Access Compliance Report

Public Rights-of-Way

(Curb Ramps)

Intersection ID: 11597	Main Street: E_20TH_ST	Cross Street: SEIGLE_AV	Location: SE
ADA ID: 0707F4CFBF08	Ramp Type: Para	Initial Pass/Fail: Fail	Overall Compliance: No
Severity Score: 12.5			
Codes/Mitigation Info/Possible Solution		Field Measurements/Component Compliance

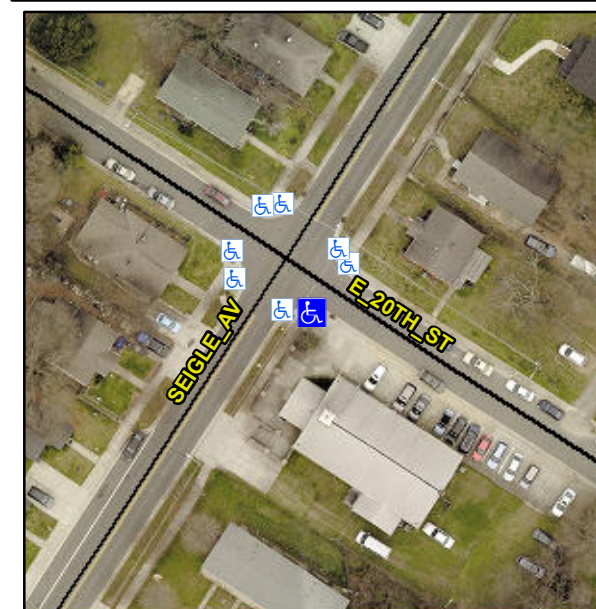
R304.3.2

Compliance	Description	Data	Compliance	Description	Data
N/A	Ramp Length LT (in)	54.0	N/A	Ramp Length RT (in)	N/A
Yes	Ramp Width LT (in)	50.5	N/A	Ramp Width RT (in)	N/A
No	Ramp Slope LT (%)	8.4	N/A	Ramp Slope RT (%)	N/A
Yes	Ramp XSlope LT (%)	2.0	N/A	Ramp XSlope RT (%)	N/A
N/A	Landing Length (in)	N/A	N/A	DWS Provided?	N/A
N/A	Landing Width (in)	N/A	N/A	DWS Contrast?	N/A
N/A	Landing Slope (%)	N/A	N/A	DWS Length (in)	N/A
N/A	Landing X Slope (%)	N/A	N/A	DWS Full Width?	N/A
N/A	Landing Curb? (Y/N)	N/A	N/A	DWS Offset (in)	N/A
N/A	Shared Landing?	N/A			
N/A	Gutter Ponding?	N/A	N/A	Gutter Slope (%)	N/A
N/A	Gutter Lip Ht (in)	0.5	N/A	Gutter X Slope (%)	N/A
N/A	Painted X Walk1?	No	N/A	Painted X Walk2?	N/A
	X Walk 1 Direction	To NE		X Walk 2 Direction	N/A
N/A	X Walk 1 Width (in)	N/A	N/A	X Walk 2 Width (in)	N/A
	X Walk 1 Slope (%)	7.3		X Walk 2 Slope (%)	N/A
	X Walk 1 X Slope (%)	0.4		X Walk 2 X Slope (%)	N/A
N/A	Ramp inside XWalk1?	N/A	N/A	Ramp inside XWalk2?	N/A

Remove & Replace Entire Ramp.
